APPLICATION FOR DRIVEWAY CUTS AND OPENINGS

CITY OF CAMBRIDGE

Address of proposed curb cut or off-street parking facility: 37 LANCASTER STREET

Re: 37 Lancaster Curb Cut Notice

Site Plan
Scale: 1/8" = 1'-0"
April 6, 2011

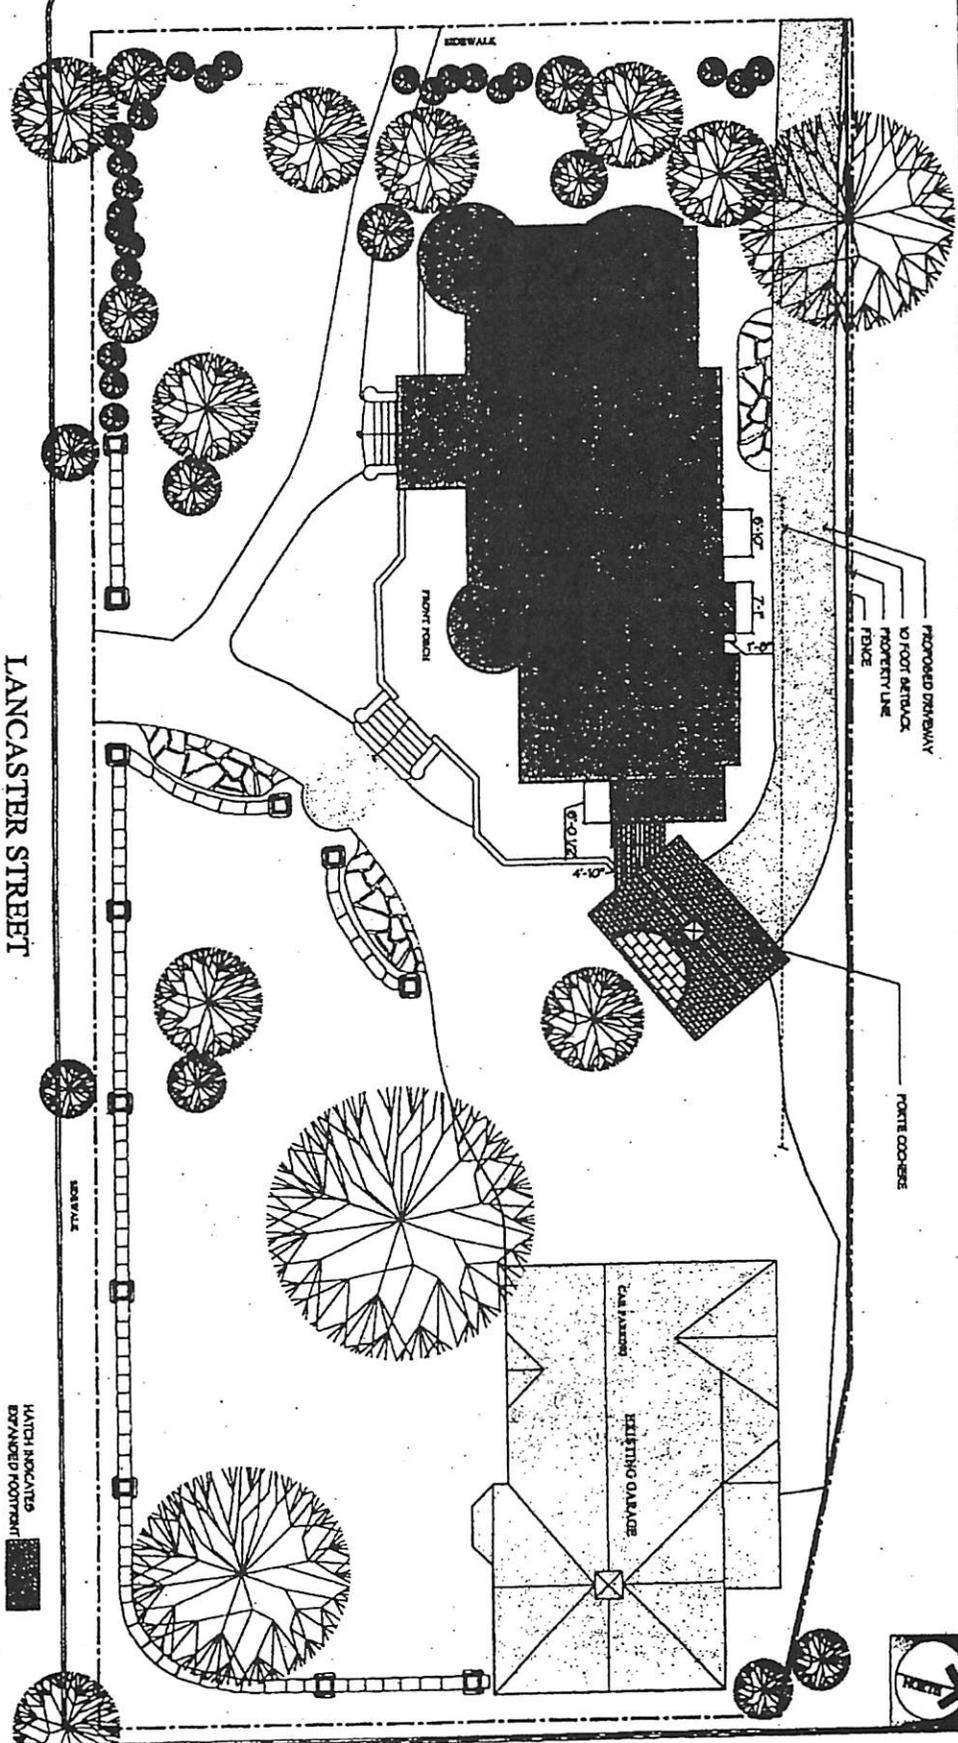
The Curb Cut Application lacks information necessary for both ISD and abutters to determine whether the project complies with applicable zoning regulations. No setbacks are provided so setbacks from intersections and/or crosswalks can not be determined as required under § 6.40 of the Cambridge Zoning Ordinance. Further, it is impossible to calculate if the large additional paved area leaves the site in compliance with the private open space limitations of § 5.22. Given the absence of information in the Application, it is unclear that the project results in either 50 percent private open space under § 5.22.1 or 25 percent permeable or green open space under § 5.22.3. ISD is charged with reviewing zoning compliance for this Application and this information must be provided in order for these determinations to be made. Also, information on compliance with both Traffic, Parking and Transportation and Department of Public Works specifications (e.g., sightlines and slopes) is omitted. Absent this information, neither the neighbors nor ISD can fully and fairly review the Application.

application. In the interim, until he has an opportunity to do so, Mr. Friedman is left with no choice but to object to the present incomplete application.
